PRESCOTT PRESERVATION COMMISSION A G E N D A

**PRESCOTT PRESERVATION COMMISSION
REGULAR MEETING/PUBLIC HEARING
FRIDAY, April 8, 2011
8:00 AM**

**PRESCOTT PRESERVATION COMMISSION
COMMUNITY DEVELOPMENT DEPARTMENT**

AGENDA ITEM: HP11-003 Request for approval of tenant improvements to the interior of an existing commercial space at 108 W Gurley St.

Agenda Item: HP11-002, 207 W Gurley St

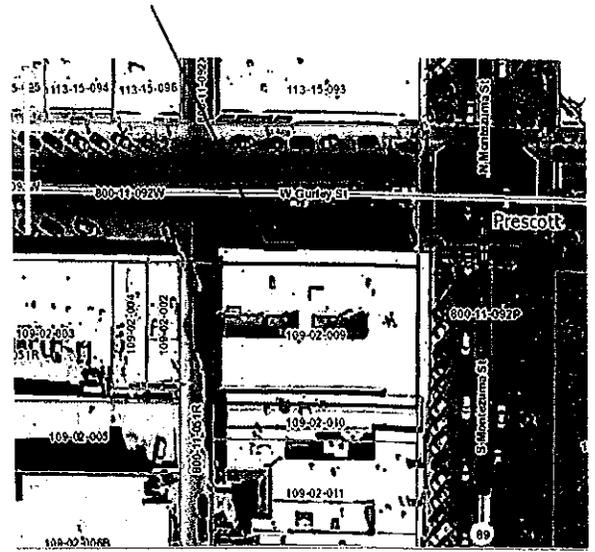
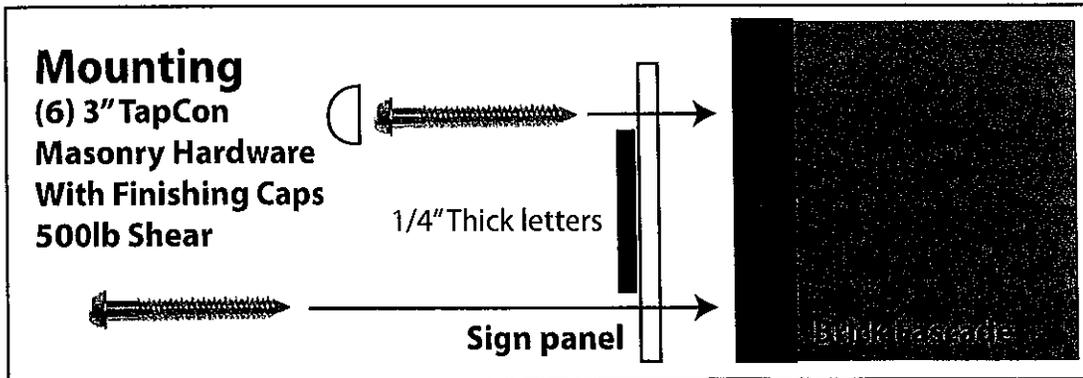
- All signage should be placed flat against the facade. One suspended perpendicular sign per building is permitted.

The proposed signage complies with all requirements of the design guidelines and is well within the allotted 50 square feet of allowable signage.

Recommended Action: MOVE TO APPROVE HP11-002 Request for approval of signage for new business, La La's Salon, in existing commercial space of Hotel St Michaels building.

ARCHITECTURAL
 FLOOR PLAN
A1.1
 NOTE: DO NOT SCALE DWG.

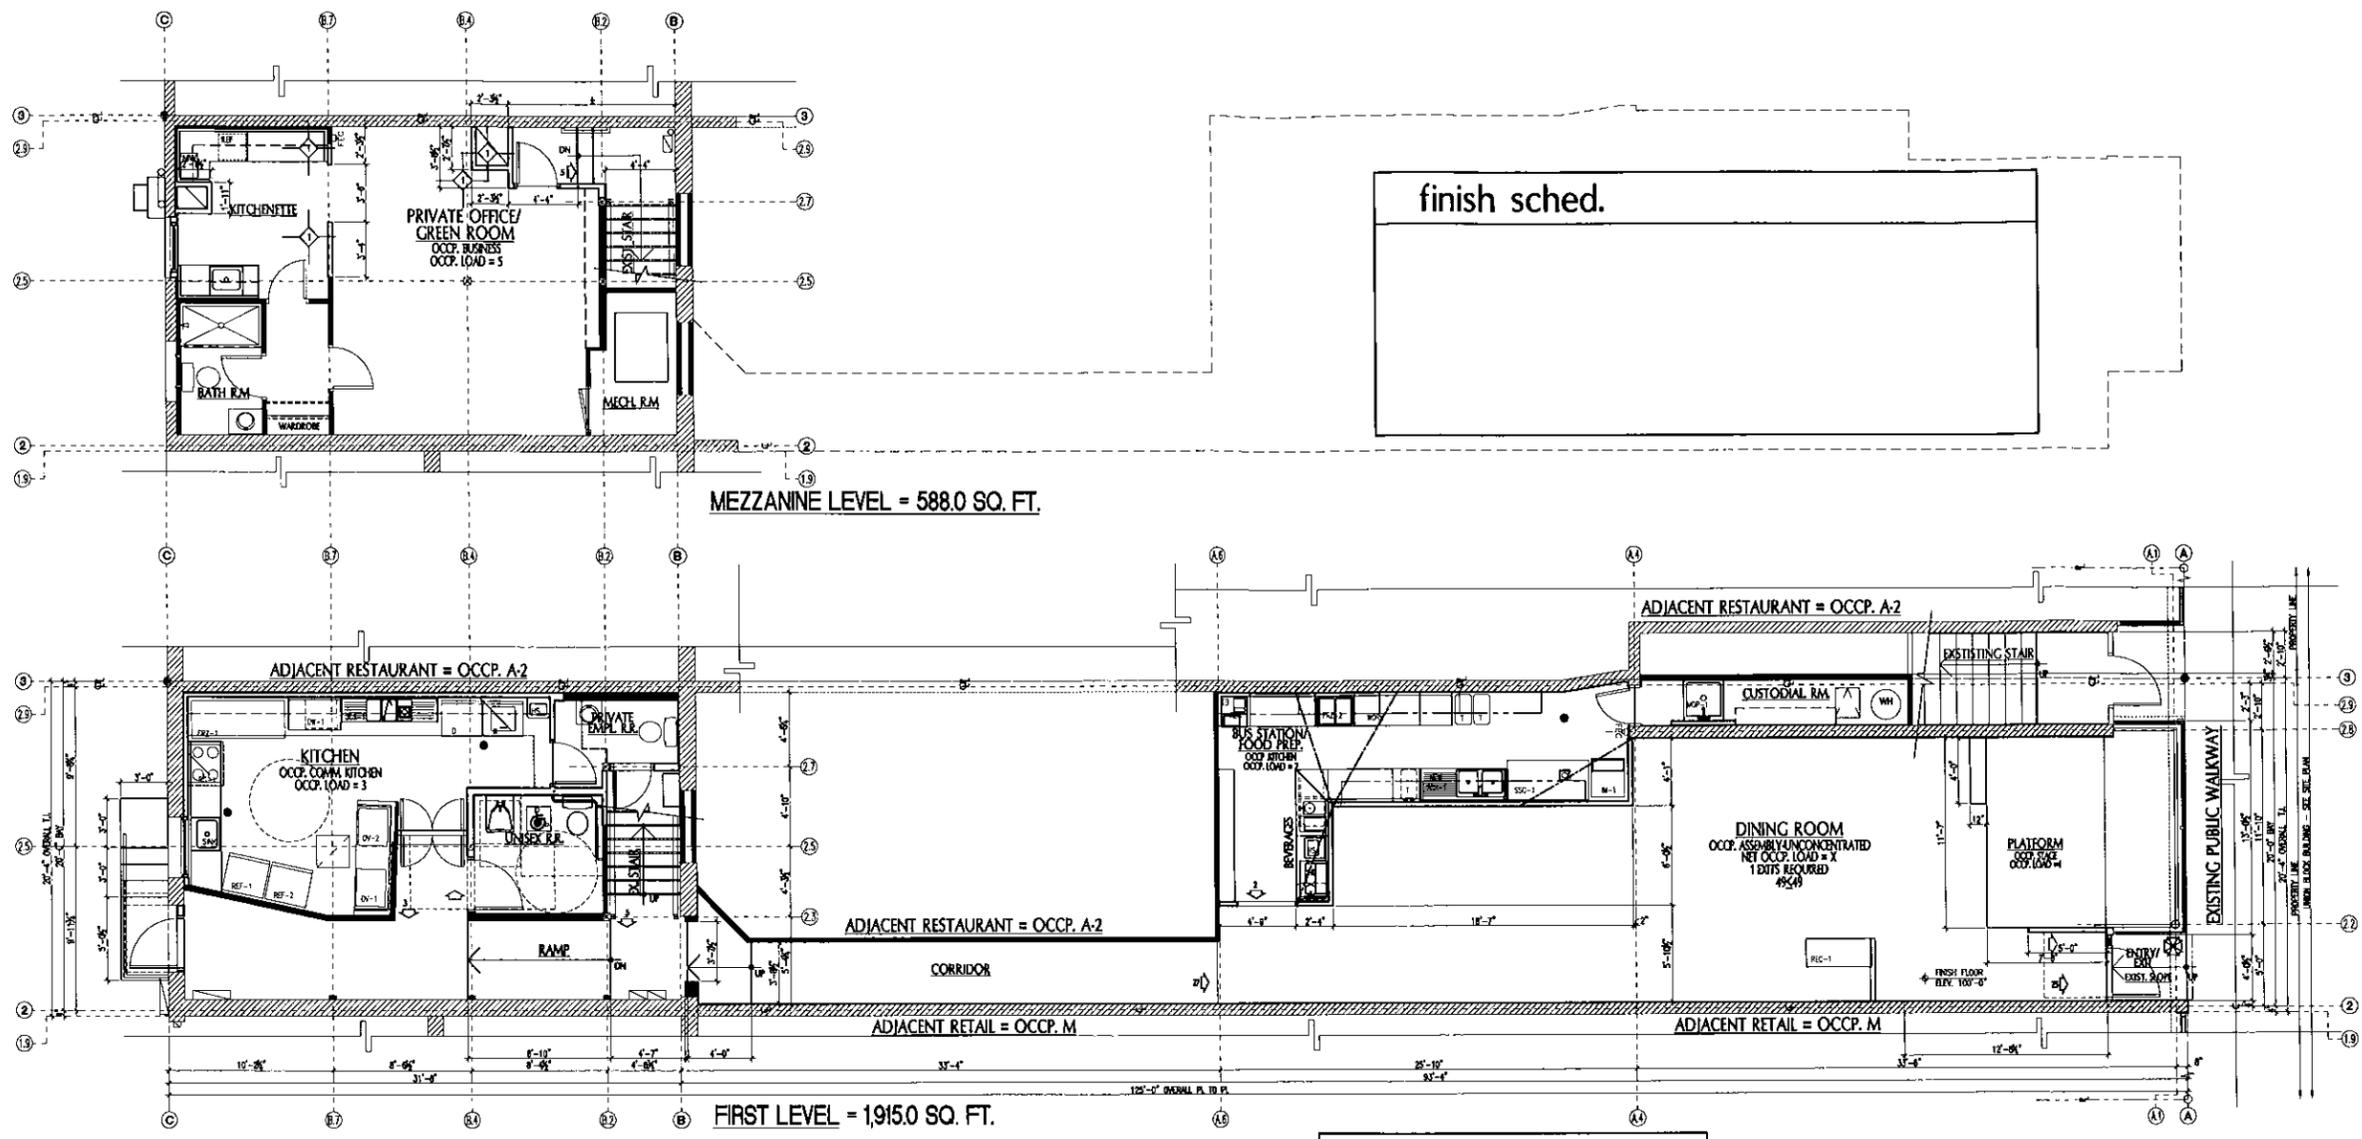
The work proposed is overall an improvement to the interior of this space, while maintaining and enhancing some of the elements that provide historic character (exposing the old tin ceiling).

The only exterior change to the building is the request for a slightly smaller door (to be similar to the existing door) with an addition of a side-light window on the handle side. This will serve to make an improvement in ADA access by allowing for more clearance for door swing and wheel chair maneuverability.

The proposed work and use for this space will not adversely impact the historic integrity of this building. It will support the goal of continued use of the historic district as a draw to both citizens and visitors.

Recommended Action: Approve or Approve with modifications. Request for approval of tenant improvements (number 1-7 in this memo) to the interior of an existing commercial space at 108 W Gurley St.
